Arborist Report

TO: Adam Merrill
SITE: St. Edwards Park Ball-field
RE: Tree Retention and Protection Report
DATE: May 6, 2016
UPDATED: August 5, 2016
PROJECT ARBORISTS: Katherine Taylor
ISA Certified Arborist PN-8022A
ISA Qualified Tree Risk Assessor

Assignment & Scope of Report

CITY OF KENMORE
 ST. EDWARD STATE PARK SPORTS FIELD
 SITE PREPARATION PLAN

Drawing No.
SP1
 Sheet No.
 of Total

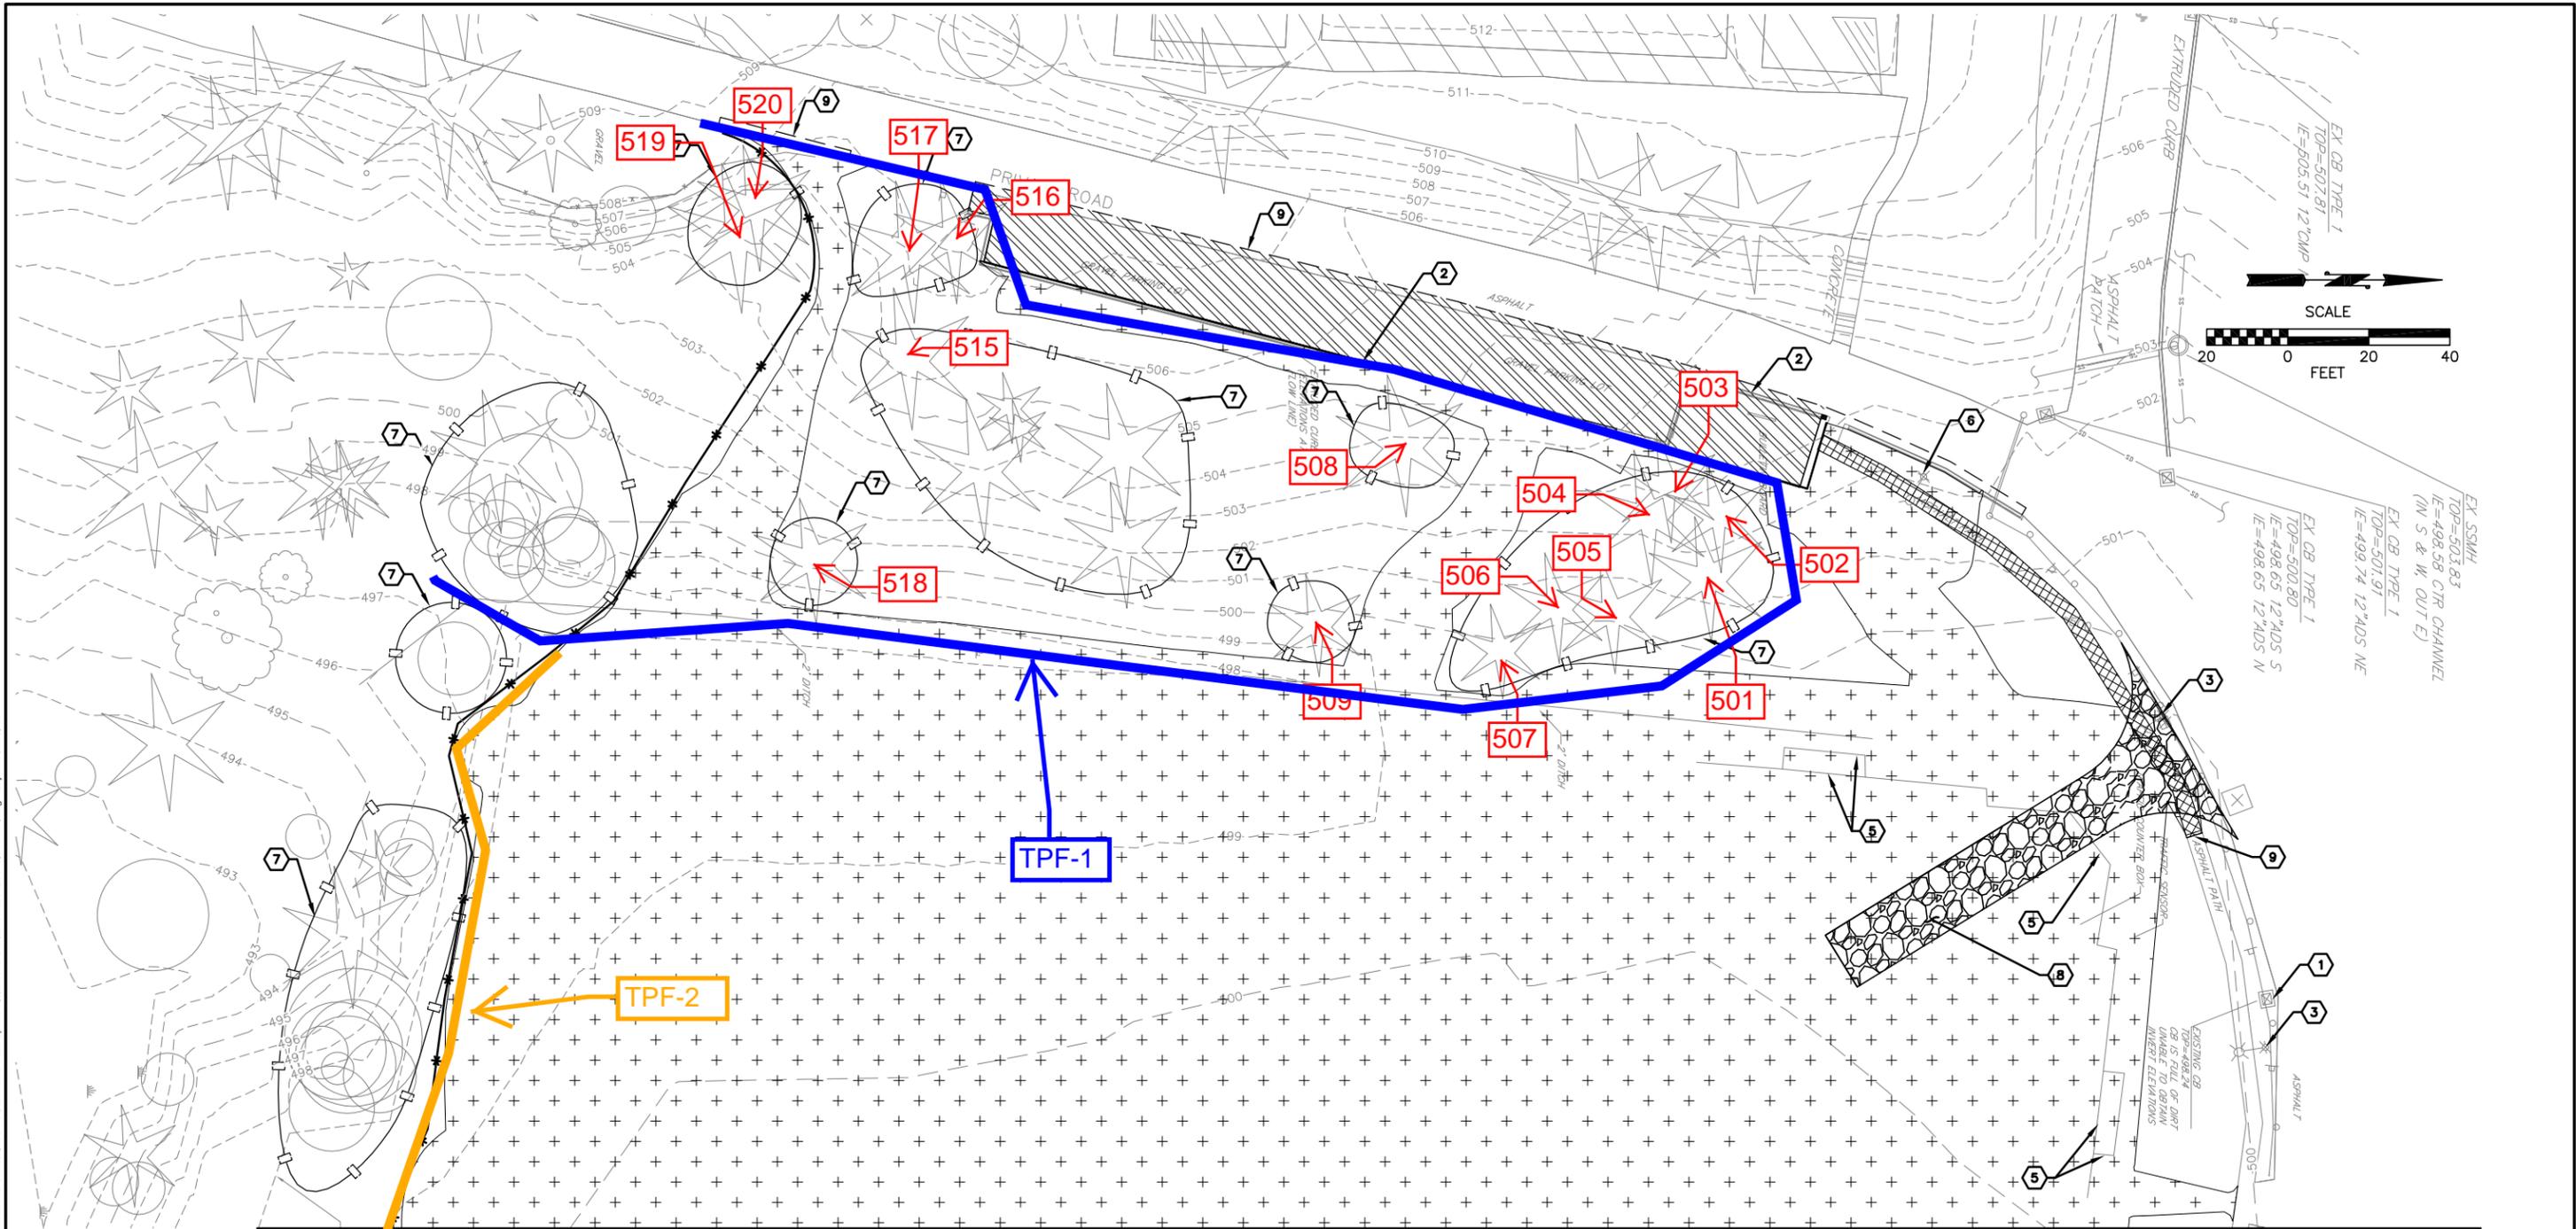
Current plans show the installation of silt fencing. Installation of silt fencing must use a detail that does not require trenching.

Installation of pervious pavement will require 18 inches of excavation and sub-grade which is typically deeper than what non-pervious pavement requires. Excavation and compaction within or adjacent to the critical root zones should be limited to the extent possible.

In the 60% Plans we noted that there are plans for hydro-seeding strips of lawn adjacent to all paths around trees 501 to 520. Grass requires significant irrigation otherwise it will die back. Because the trees have adapted to not having any additional source of water the addition of irrigation will cause further disturbance to the trees. In addition the trees have already suffered damage to their surface roots from previous mowing activities around the edge of the grove. Consider applying wood chip mulch to the edge of the paths instead of strips of lawn. Wood chip mulch will be much easier to maintain in the long run as it will not require regular mowing.

1. Tree protection shall be 5 foot tall chain link fence fastened to steel stakes or posts driven into the ground to discourage easy movement.
2. Tree protection fencing shall be installed **3 feet outside the critical root zone.**

3. To facilitate construction activities planned within the critical root zones of trees 501 through 537, tree protection fencing shall be installed in two sections (see the attached plans):

- a. **Tree Protection Fencing Zone 1 (TPF-1):** Fencing shall encompass trees 501 through 542 3 feet outside the critical root zone. This area is where new paths will be installed within the critical root zone and therefore access will be required. Fencing shall remain in place at all times except when work is occurring within TPF-1. When work occurs within this zone, fencing shall remain in place except for the portion of the fencing which shall be adjusted to allow access for construction activities.
